City of Arvada

City Council Agenda

JUNE 3, 2024

SUBJECT: R24-059, A Resolution Authorizing Change Order No. 2 to the Construction Management Agreement For Pre-Construction & Construction Services for the Meyer's Pool Replacement Project

RFI #169

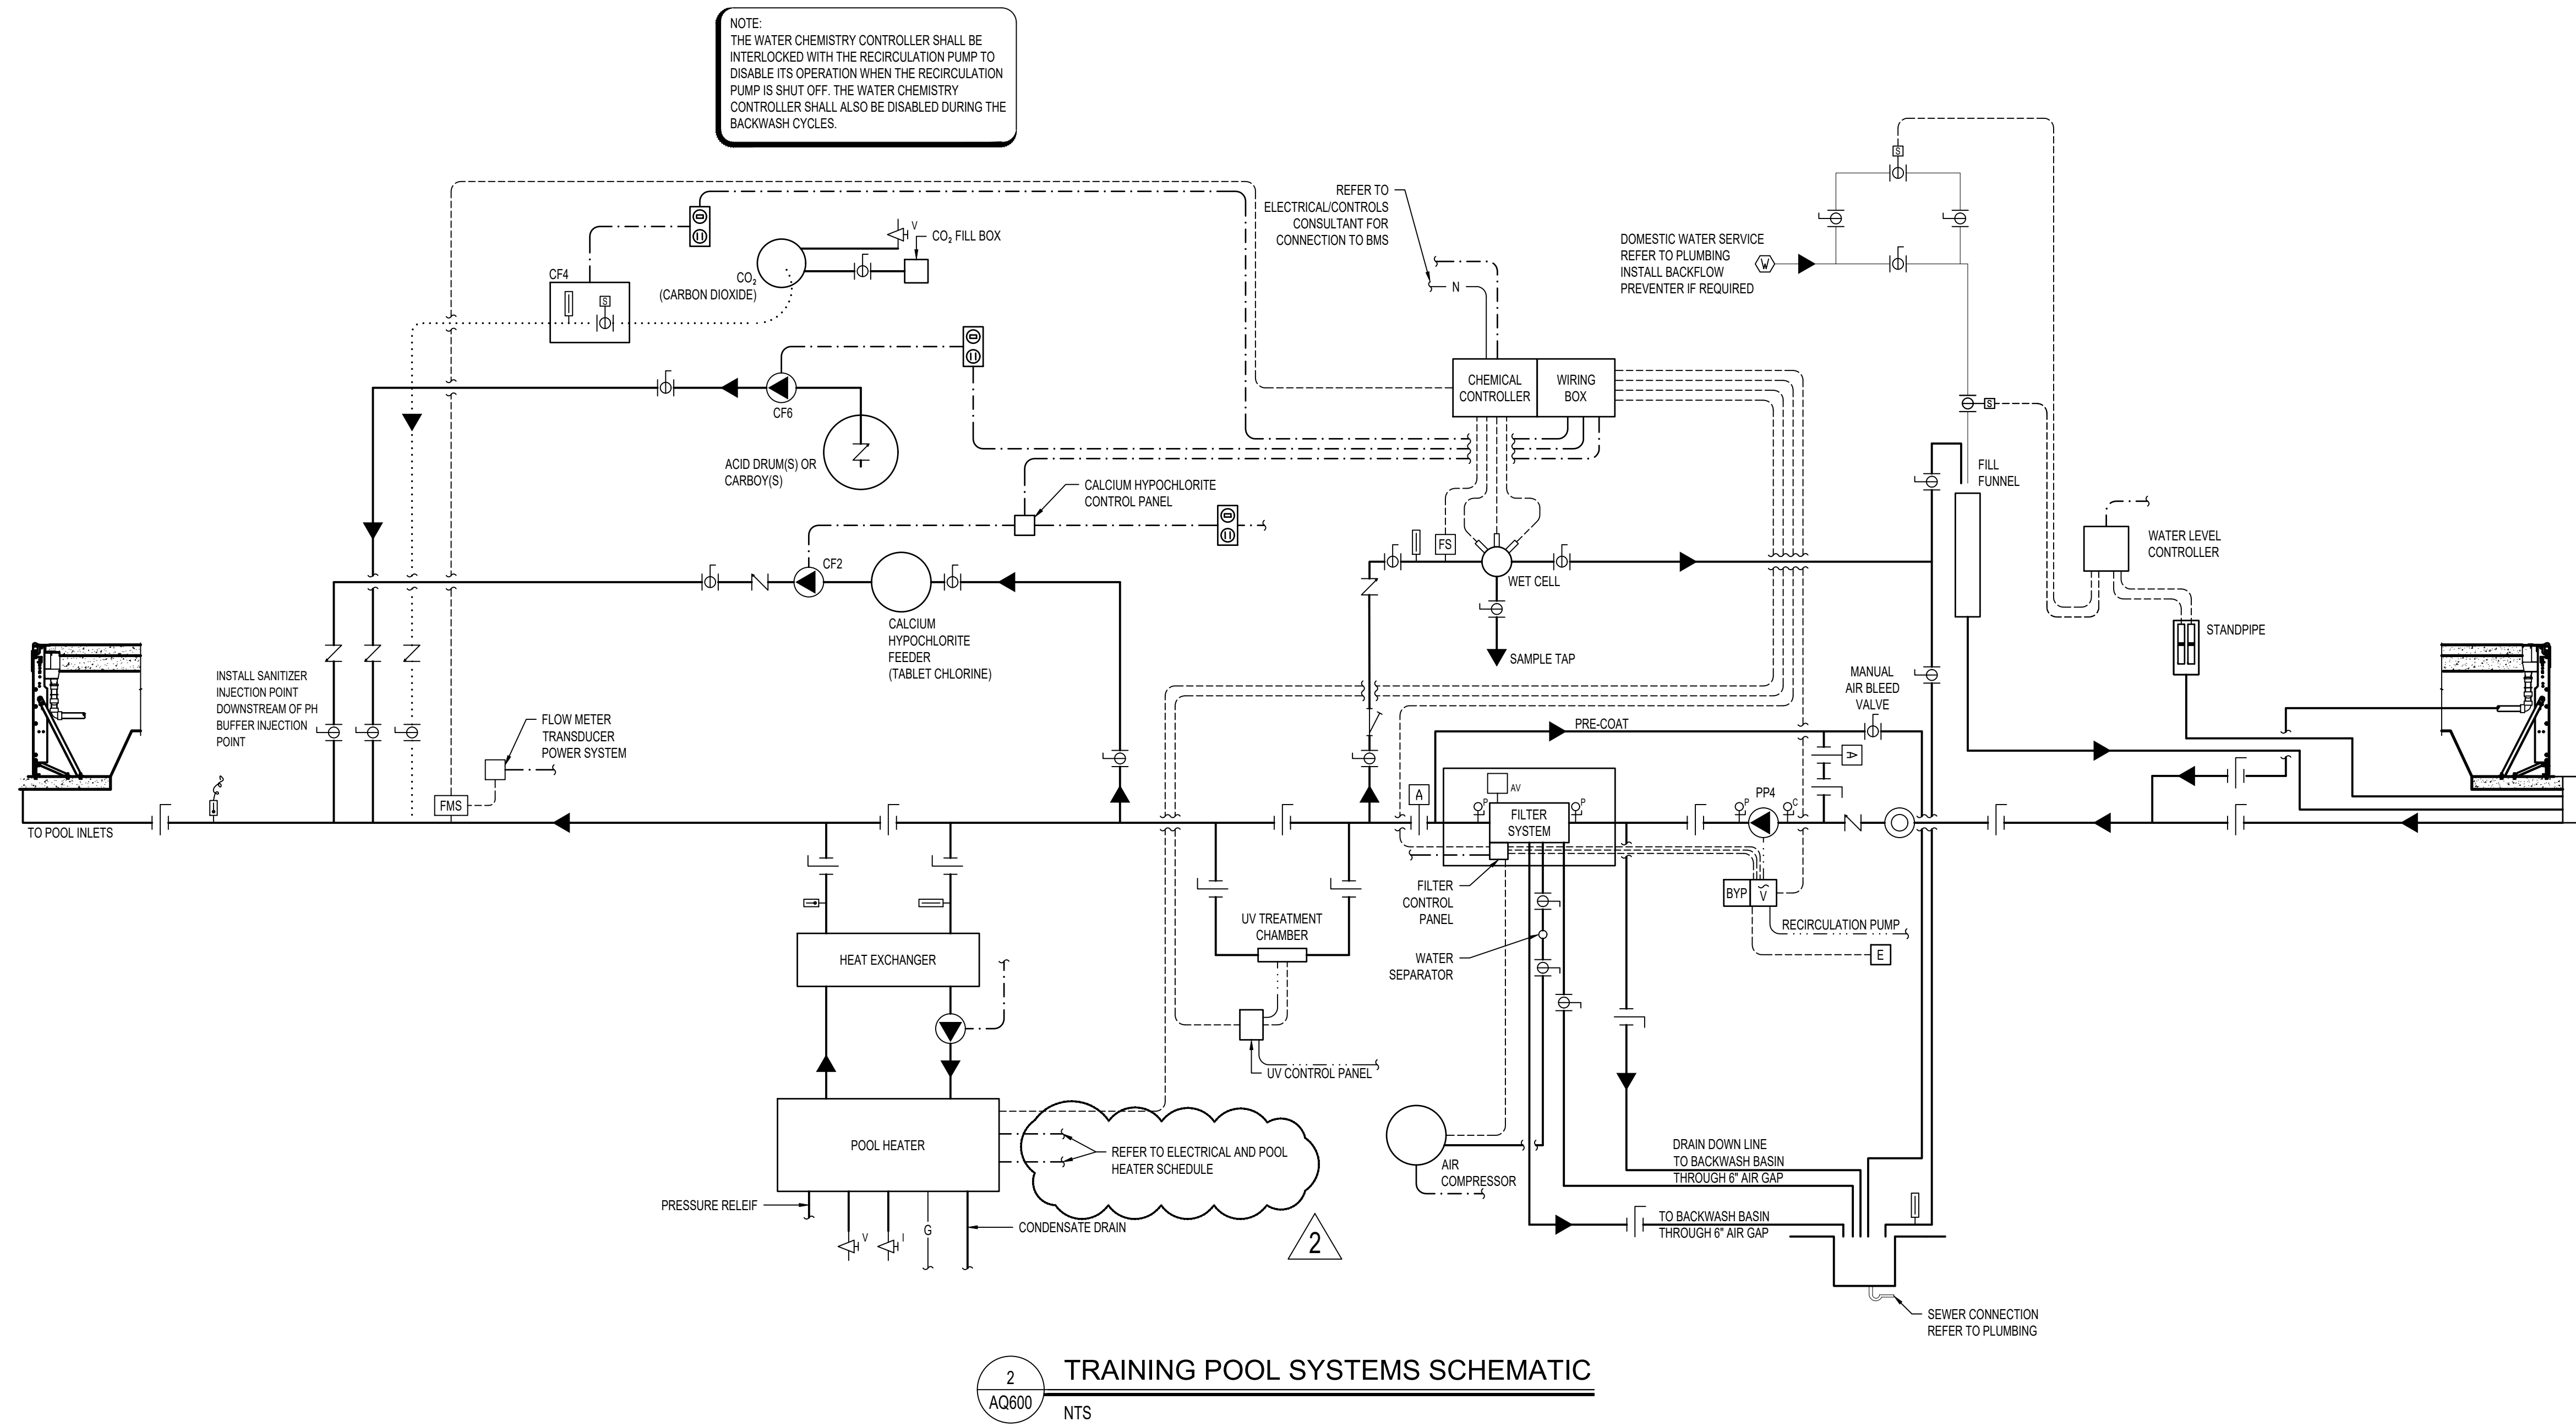
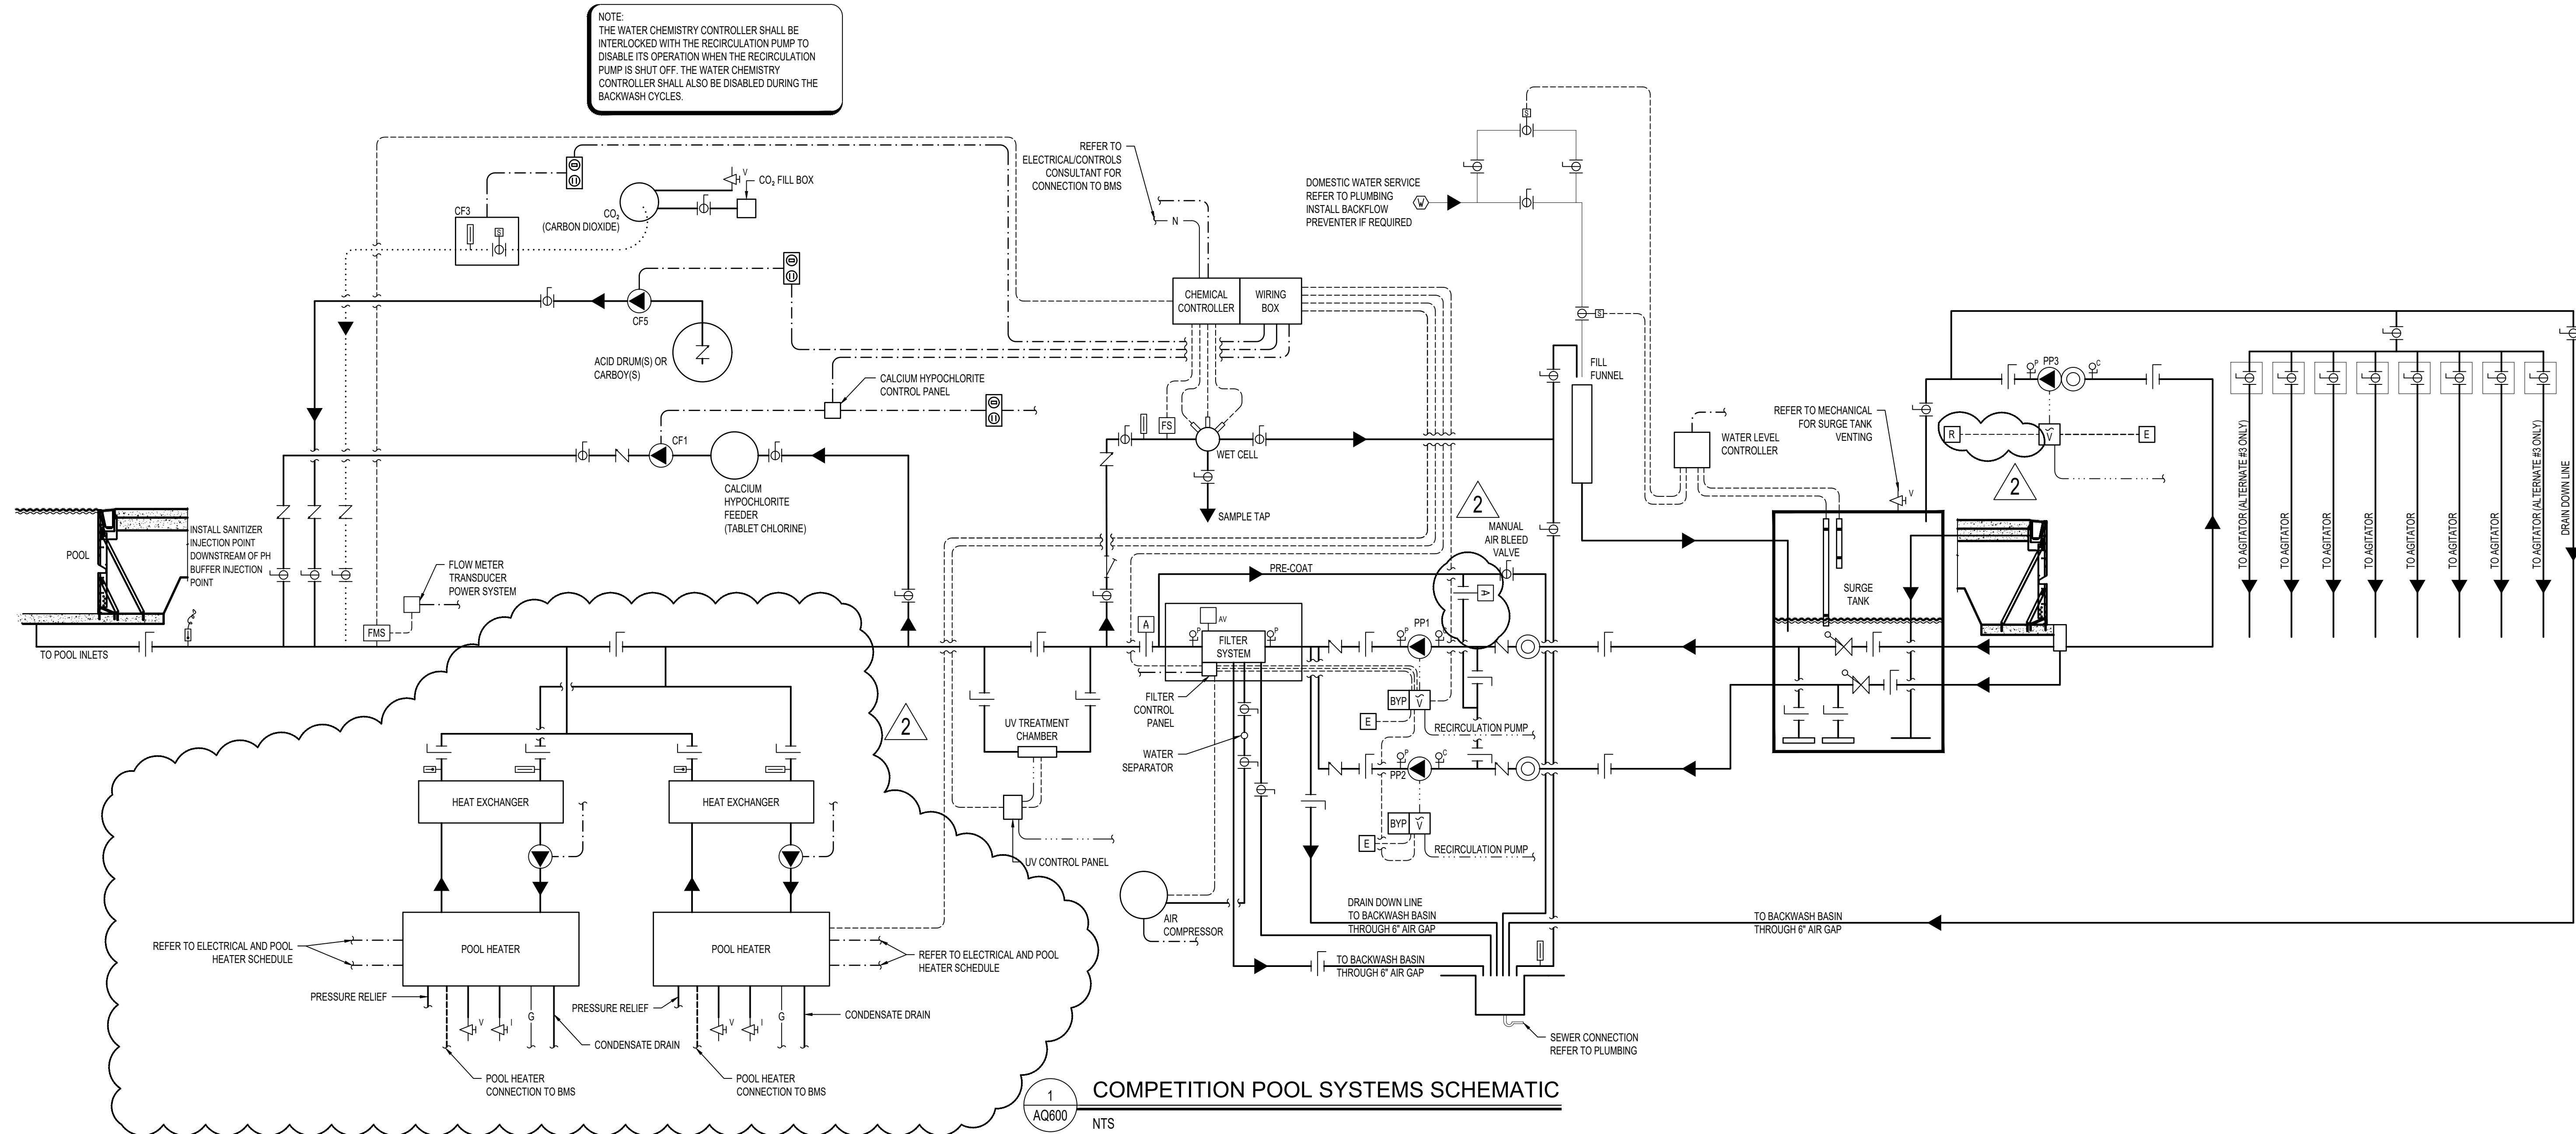
-Pumping equipment: Coordinate all motor/VFD power requirements with Electrical prior to ordering. PP3 must be WhisperfloXF model XFK-8 with TEFC motor as per the pump schedule on sheet AQ400 to allow 3-phase power, as shown on 1/AQ600. VFDs for all recirc pumps must be provided with electromechanical bypass panel option. Whisperflo XFK-8 submitted in revised submittal.

1 | FIRST FLOOR ELECTRICAL POWER PLAN - WEST
E1.01 1/8" = 1'-0"

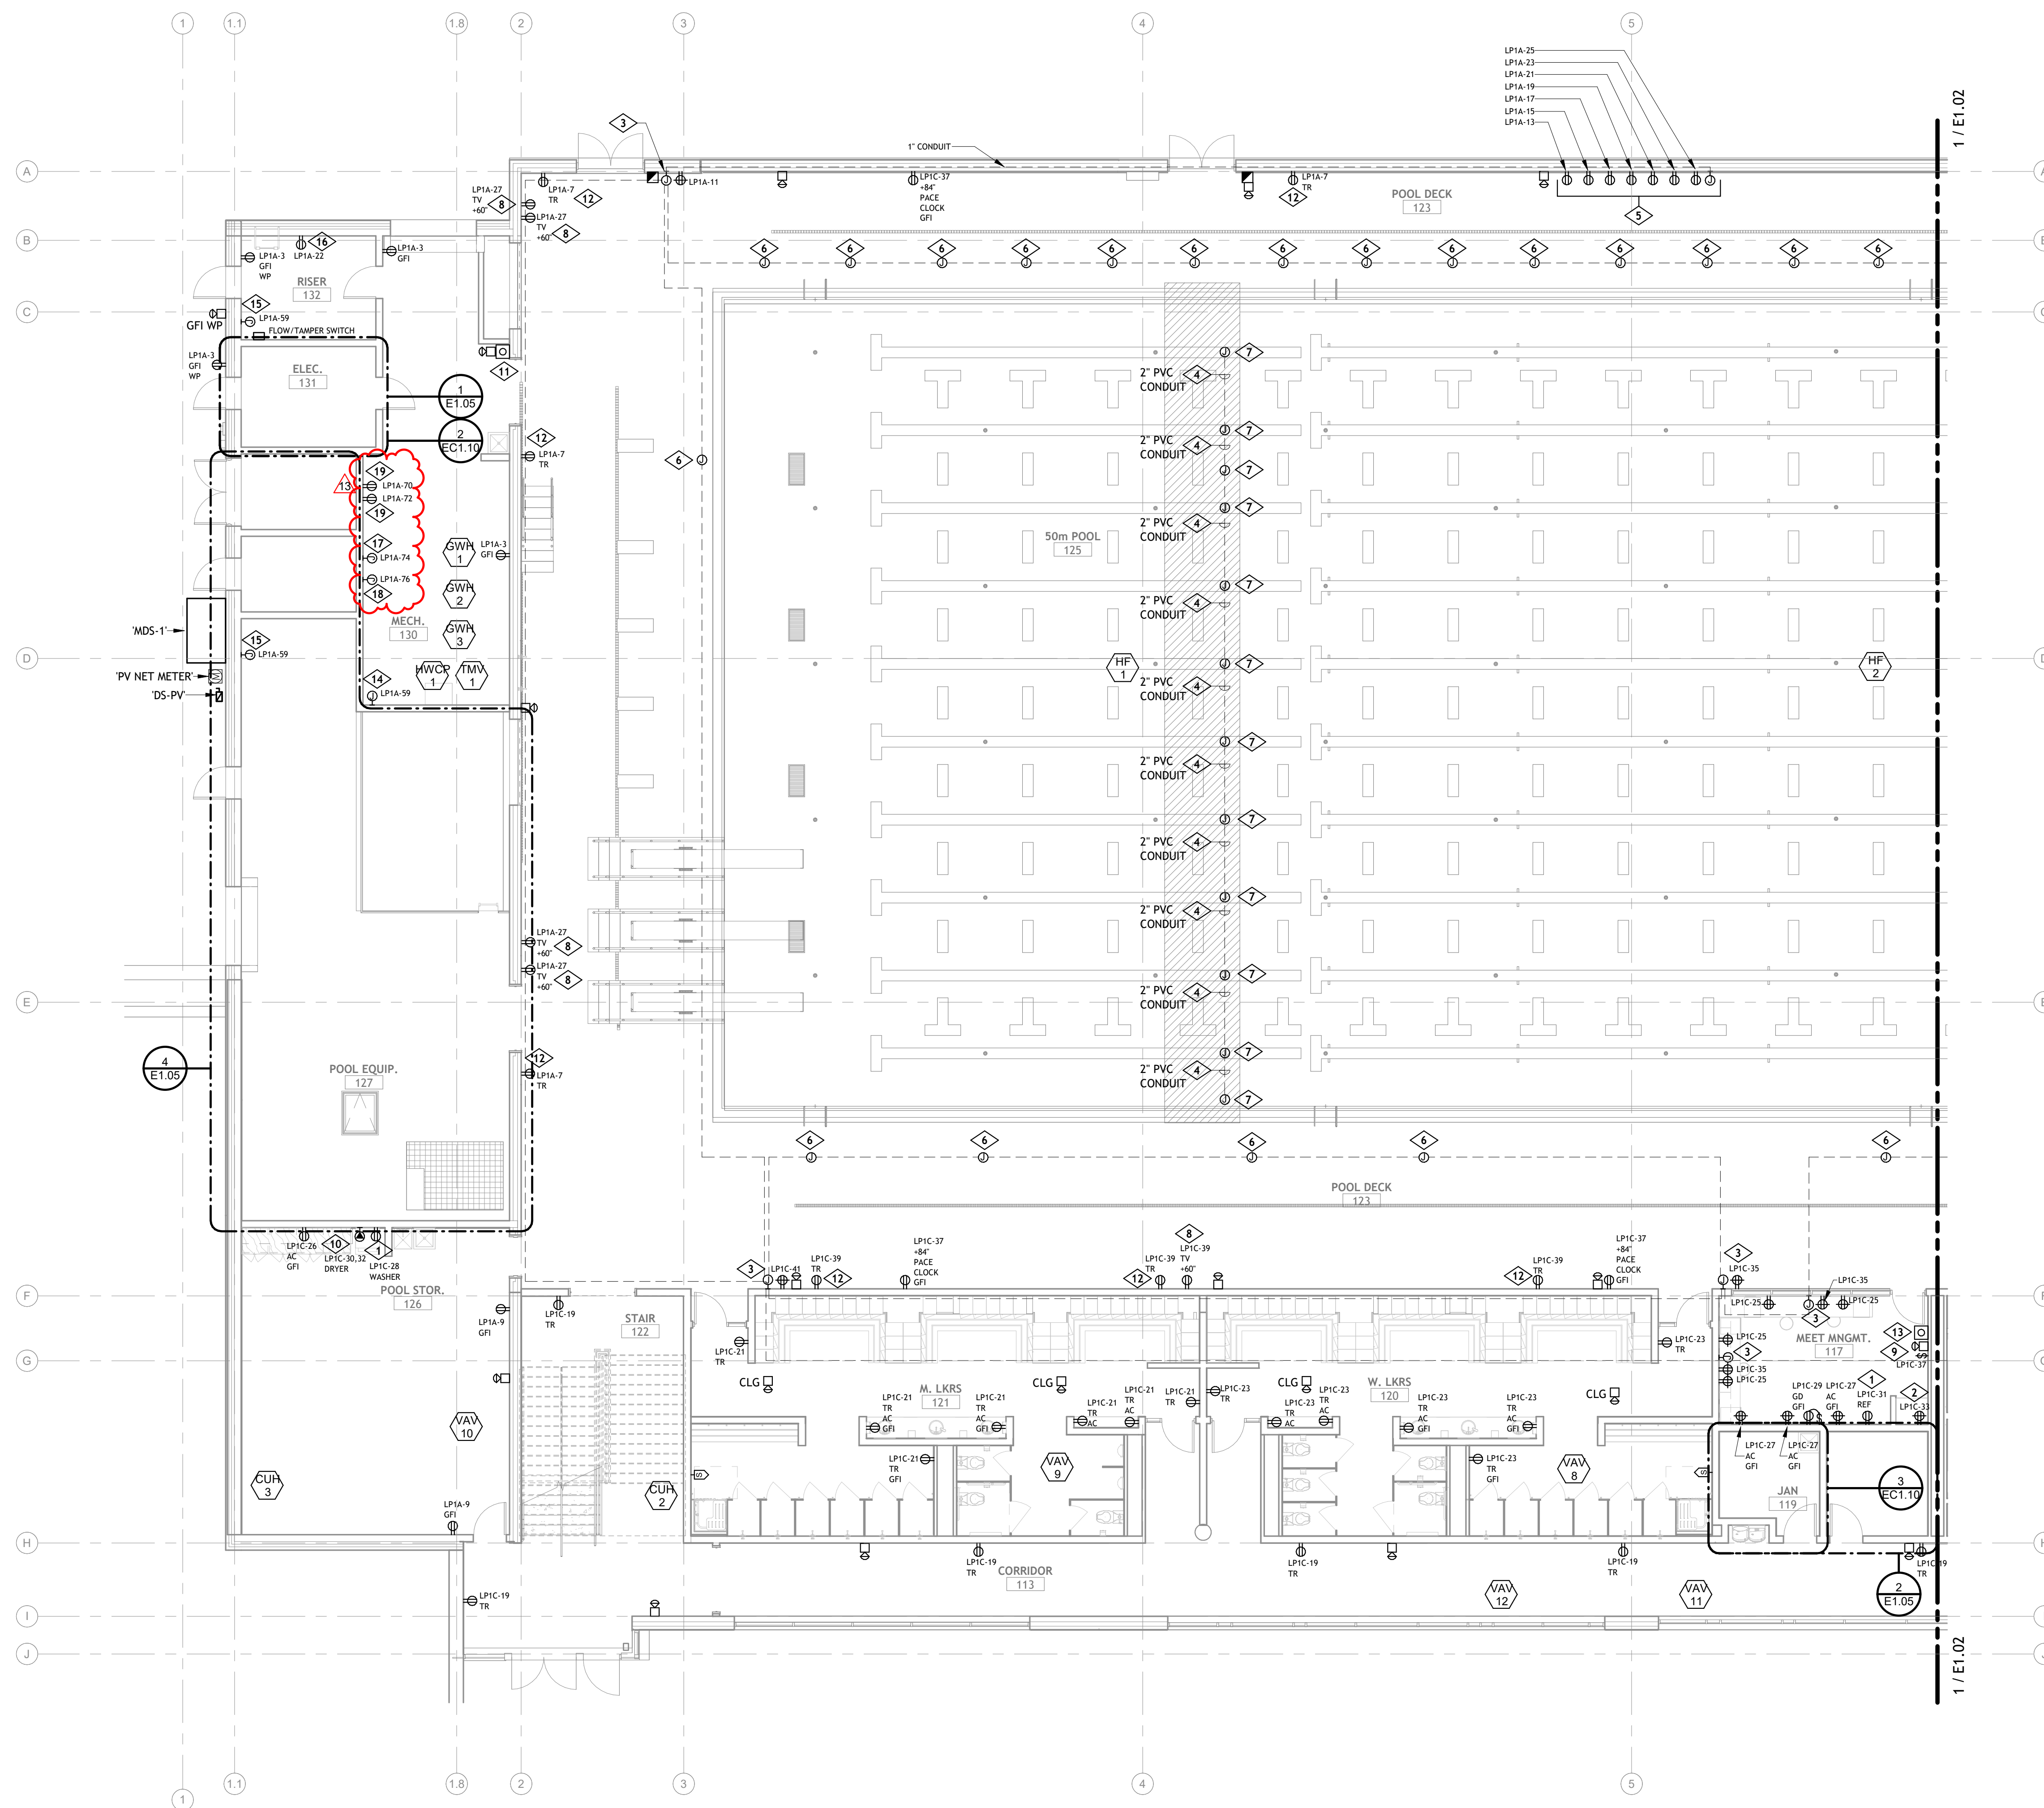
SHEET	DESCRIPTION
E1.01	Added power for intrusion control panel. Access control panel, and data cabinet.
E6.02	Revised panel schedule for additional power to intrusion control panel, access control panels and data cabinet.
T100	Revised underground conduit layout for incoming service providers. Added keynotes.
T101	Clarifications to j-hook and conduit pathway and routing requirements for low voltage telecom cabling including conduit sleeves for all cabling from Data Room 118. Clarified use of a consolidation pull box and (2) 3" conduits for all low voltage cable routing from rooms 126-132 to Data Room 118. This is in lieu of providing multiple individual 1" conduits for this entire distance from each device to the Data Room, so it simplifies pathways, provides flexibility for future cabling, and should reduce costs. Added wall-mounted Data cabinet and ACS and IDS cabinets in Mech 130. Added in-slab conduits from Data 118 to Pool Storage 126 and onward to the new cabinets in Mech 130. Added keynotes.
